IN THE MATTER of hearing submissions on Plan Change 5 to the Hamilton
City District Plan

**EVIDENCE IN CHIEF OF TONY PENNY
FOR THE ADARE COMPANY LIMITED**

TRANSPORT

16 SEPTEMBER 2022

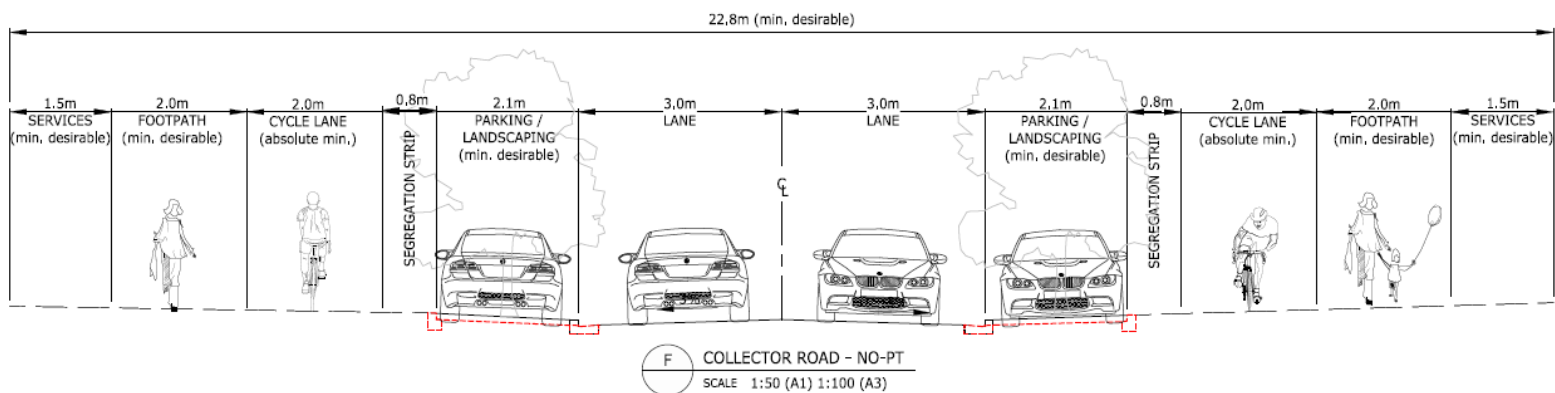
16. HCC have accepted Adare’s submission seeking to add design criteria in PC5 (Table 15-6b) for Minor Arterial Roads so landowners affected by undesignated roads have a better understanding of the effects of future land acquisition. Subject to the minor correction to the berm width shown in the table in Attachment 1, I support the design criteria details for Minor Arterial Roads recommended in the S42A report that are also shown in the following diagram.¹

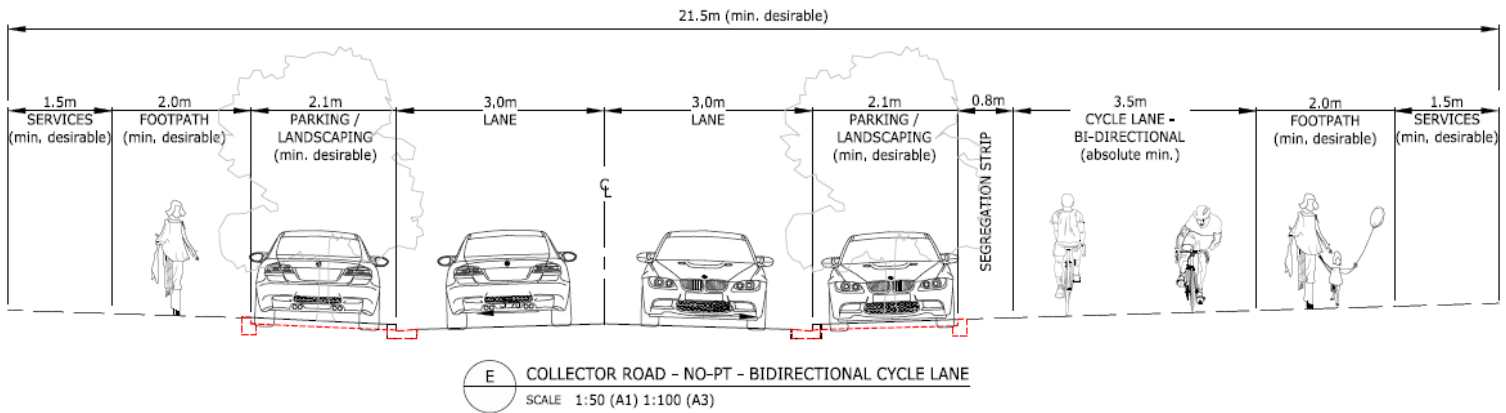
17. The minimum desirable width of the service corridor for Collector Roads in Table 15-6b is specified as “2m both sides.” The equivalent service corridors for Local Roads and Minor Arterial Roads are both shown as having a minimum desirable width of 1.5m. The evidence of Ray O’Callaghan is that there is no logic for having the service corridor for Collector Roads wider than the service corridor for Minor Arterial Roads.

He considers that 1.5m would be an appropriate minimum desirable width for service corridors on Collector Roads (as well as Minor Arterial Roads and Local Roads).

18. I also consider that the carriageway widths for Collector Roads with public transport (PT) routes (6.8m) and non-PT routes (6.4m) are more than are desirable to avoid higher speeds. Allowing wider roads (enabling higher speeds) is not supported by the policies related to prioritising safety for pedestrians and cyclists. The Adare submission sought that the carriageway widths should be reduced to 6.4m (PT route) and 6.0m (non-PT route) as indicated in the following diagram. I support these reductions as the narrower width would reduce vehicle speeds and improve road safety. The below diagram shows my proposed amendments for a Collector Road (non-PT route).

19. In his evidence, Mr Black refers to the Auckland design standard requiring 6.4m wide carriageways for collector routes except for those accommodating very large buses.² The Collector Roads that are PT routes in the PSPA are unlikely to need to accommodate large buses. As such, I consider that a 6.4m wide carriageway for Collector Roads on PT routes would be more appropriate. Logically, Collector Roads which are not PT routes could have narrower (and safer) carriageways so a reduction from 6.4m to 6.0m for their carriageway widths would be appropriate.

20. The S42A report version of Table 15-6b has a minor error in that Collector Roads with PT should have a berm width of 8.9m not 8.8m. With the other changes that I have recommended, this would reduce berm width to 8.4m as indicated in Attachment 1.

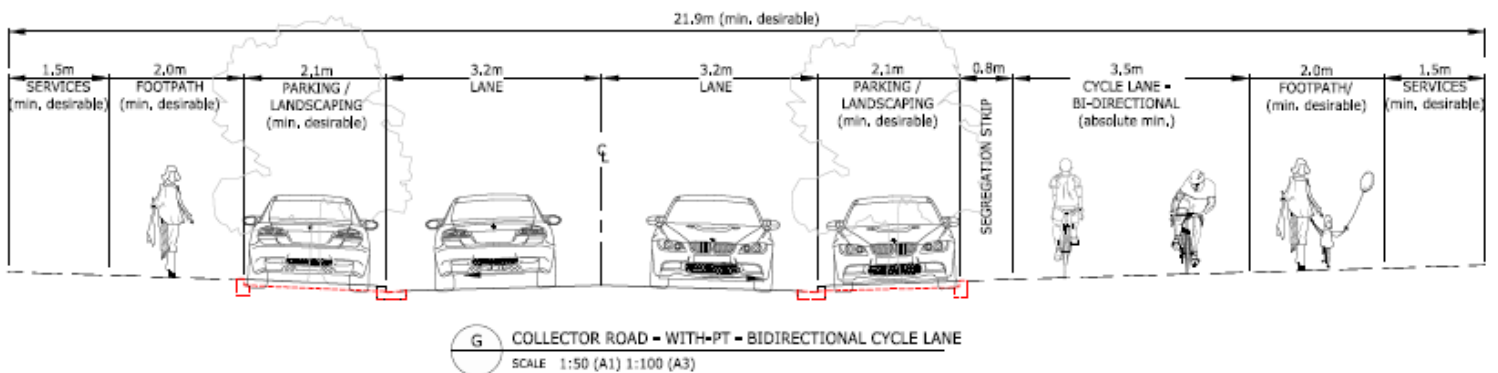
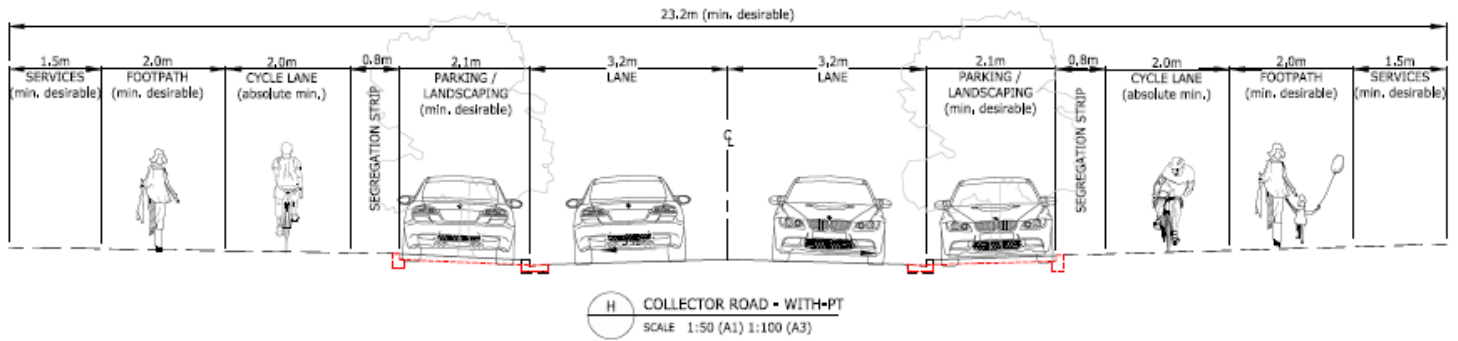
21. I support the concept of allowing a single bi-directional cycle facility to be provided on one side of a Collector Road as indicated in the following diagram. While this alternative is included in the cycle requirements in Table 15-6b, it is not reflected in the other criteria such as the legal road width which is reduced. I have modified the details in the version of Table 15-6b in Attachment 1 and recommend that these are adopted. The diagram below depicts a non-PT collector road with a bidirectional cycle lane.

22. The below images show the collector roads with transport, for completeness.

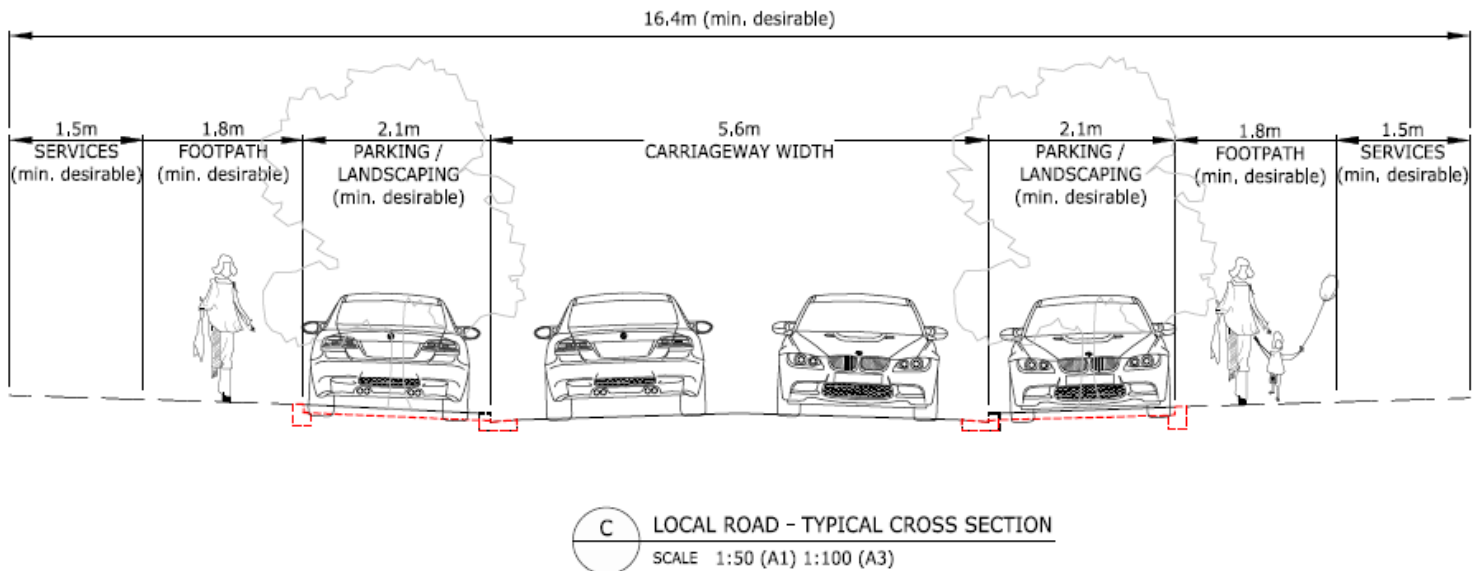
23. I support all but one of the design criteria for Local Roads in the S42A report version of Table 15-6b. The one criterion that I consider should be changed is the carriageway width, which should be specified as 5.6m rather than 6.0m. This change would reduce vehicle speeds and optimise the environment for pedestrians crossing the street and cyclists who are required to share the movement lanes with motor vehicles.

24. The cross section proposed for Local Roads is indicated in the following diagram.

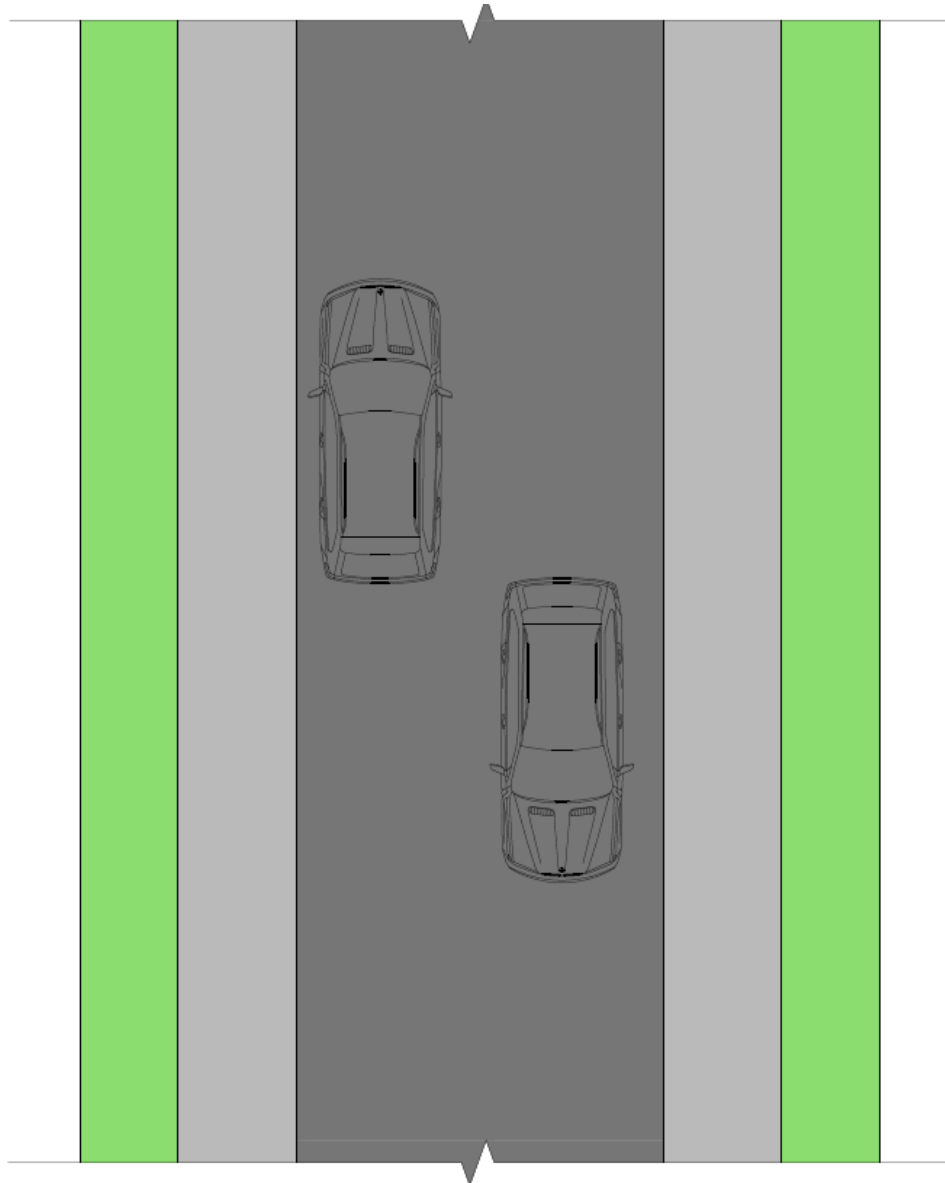
33. I support the introduction of this road category, and the criteria specified in the S42A report, except for the carriageway width which has been indicated as 6.0m compared with the 5.6m wide carriageway proposed by the Adare submission on PC5. Section 3.2 of the JWS for the Planning and Transport conferencing records that Mr Black and I agreed with a 5.6m carriageway width for these roads.⁵

34. As was also agreed at the Planning and Transport conferencing,⁶ the berm widths in Table 15-6b should be 3.3m (1.5m service corridor plus 1.8m footpath) on the side opposite the open space and 2.5m (2.1m parking bay plus 0.4m for the kerb at the back of the parking bay) on the open space side.

35. With the agreed carriageway width (5.6m) and berm widths (3.3m and 2.5m) above, the legal road width for open space edge roads included in Table 15-6b should be 11.4m not 11.8m. These corrections are shown in **Attachment 1**.

B NEIGHBOURHOOD STREET - 2 CAR WIDTH
SCALE 1:50 (A1) 1:100 (A3)

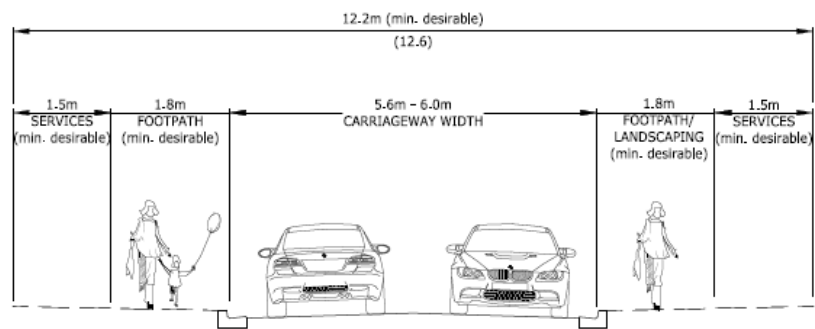
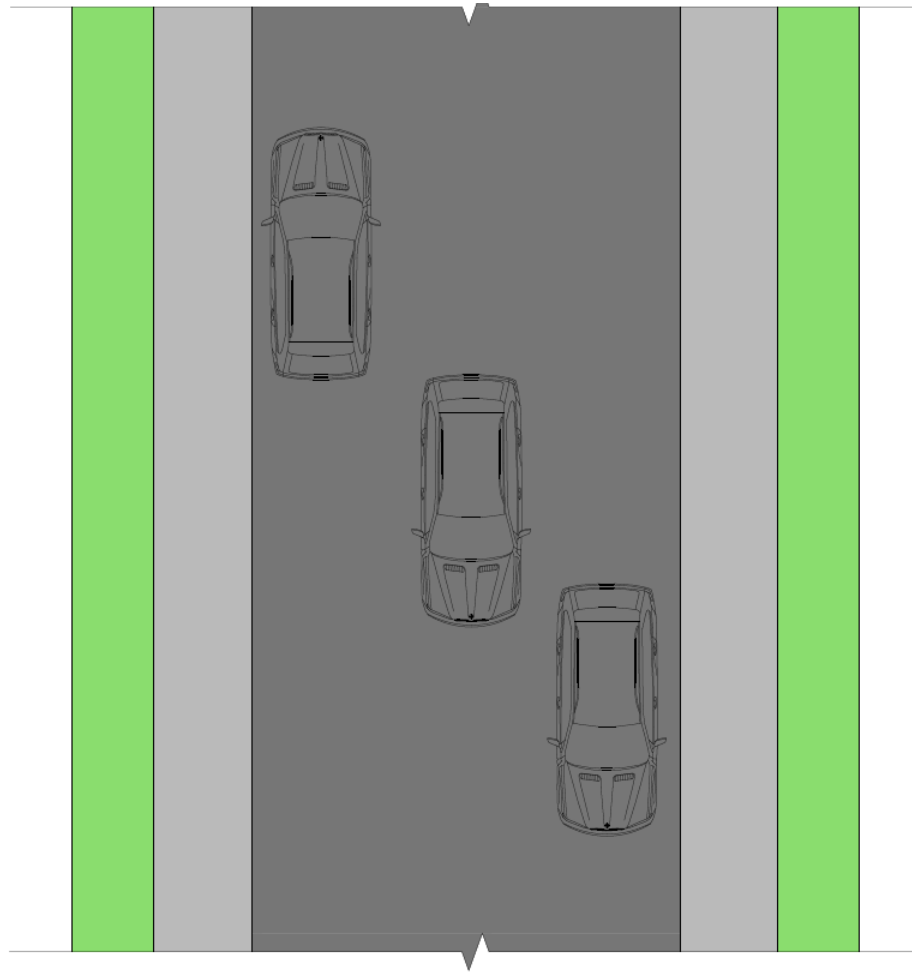
44. Based on Neighbourhood Streets having kerbside parking, I have recommended two acceptable ranges for the carriageway width. The first and narrower range (5.6m-6.0m) that effectively accommodates just two car widths applies to shorter Neighbourhood Streets (say up to 75m for a cul-de-sac and 125m for dual access road) This can involve the two-way movement of vehicles along the street where there are no cars parked at the kerbside or the one-way movement of vehicles passing cars parked at the kerbside. The proposed configuration is illustrated in the diagram following and the detailed changes to the S42A design criteria are shown in Attachment 1.

A NEIGHBOURHOOD STREET - 3 CAR WIDTH
 SCALE 1:50 (A1) 1:100 (A3)

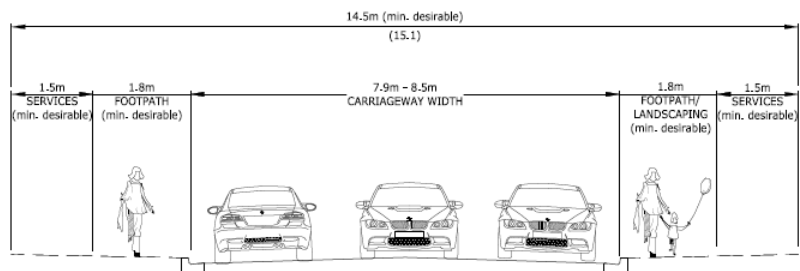
45. The second acceptable range for the width of Neighbourhood Street carriageways (7.9m-8.5m) relates to streets that serve more lots and that can accommodate three car widths. The operation of these streets can involve the two-way movement of vehicles along the street where there is kerbside parking only on one side or the one-way movement of vehicles passing cars parked at the kerbside on both sides. This is illustrated in the following diagram.
